Work Order ID 96762

Item Name: Crosstube Assembly, Mid Fwd

DRAWING NO. D206-667-147	TITLE CROSSTUBE ASS'Y (206L MID FWD)	REV. A	DART AEROSPACE LTD ENGINEERING ORDER		D.E.O. NO. D206-667-147-A-1	SHEET NO. SHEET 1 OF 1	SCALE NTS
DRAWN 9P	CHECKED AJS	MFG. APPR. [Signature]	APPROVED [Signature]		DE APPR. [Signature]		
DATE 11.07.15	DATE 11.07.20	DATE 11.07.21	DATE 11/07/21		DATE 11.07.21

DRAWING NO. D206-667-147	TITLE CROSSTUBE ASS'Y (206L MID FWD)	REV. A	DART AEROSPACE LTD ENGINEERING ORDER		D.E.O. NO. D206-667-147-A-2	SHEET NO. SHEET 1 OF 1	SCALE NTS
DRAWN AJS	CHECKED	MFG. APPR.	APPROVED		DE APPR.		
DATE 12.08.02	DATE 12.08.02	DATE 12.08.02	DATE 12.08.02		DATE 12.08.02	DATE 12.08.02

DETAIL P
 BONDING STRAP INSTALLATION 2 PL

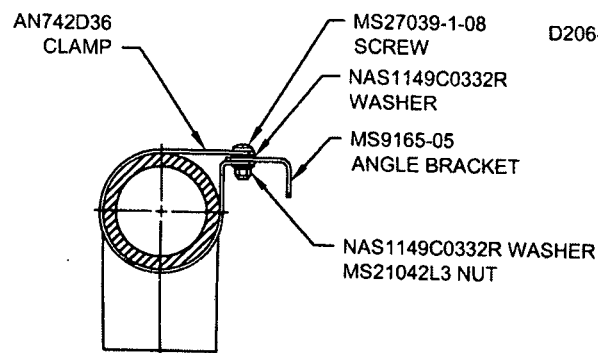
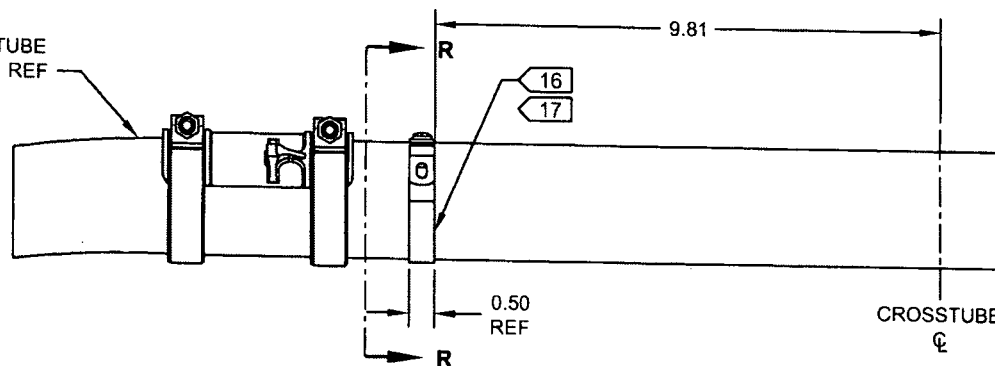
PURPOSE:

ADD ELECTRICAL GROUNDING STRAP

CHANGE:

ITEM	QTY	PART NUMBER	DESCRIPTION
1	X	D206-667-147	CROSSTUBE ASSEMBLY (206L MID FWD)
10	2	AN742D36	CLAMP
11	2	MS9165-05	ANGLE BRACKET
12	2	MS21042L3	NUT (OR MS21042-3)
13	2	MS27039-1-08	SCREW
14	4	NAS1149C0332R	WASHER (OR AN960C10L)

- 16) MASK AREA UNDER CLAMP PRIOR TO PAINTING
 17) SEAL EDGES WHERE AN742D36 CLAMP MEETS WITH THE CROSSTUBE USING SIKAFLEX-241/291 OR MIL-S-8802 CLASS B2 OR PROSEAL 890 SEALANT
 18) PERFORM RESISTANCE CHECK TO ENSURE MAX RESISTANCE IS 10 MILLIOHMS
